RFI 112

Project: COOLEY LABORATORY RENOVATION  
Job: 3146 COOLEY LAB, PPA# 10-0023  
Customer: STOFMT MSU BOZEMAN

OWJ @ ELEVATOR ADDITION - BOTTOM CHORD CONNECTION

**9 (N) BEAM/(E) OWJ**

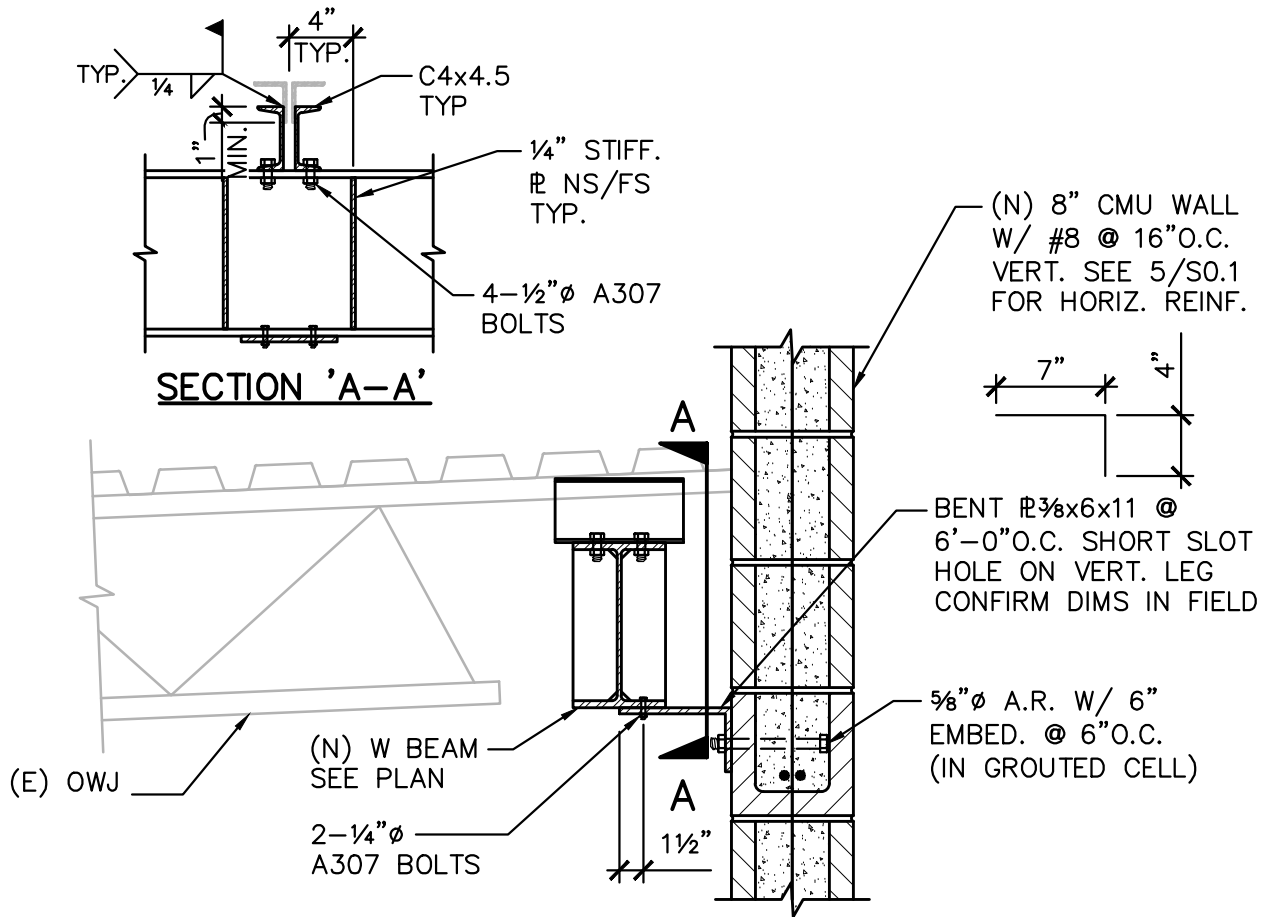
QUESTION:  
During construction of the Elevator addition the Existing OWJ were cut to install a Wide Flange beam. The bottom chord condition varies but the distance from the new wide flange beam bearing point and the web connection on the bottom is 22" - 24". Is this condition acceptable?

MAX. DISTANCE  
FIELD 22"-24"
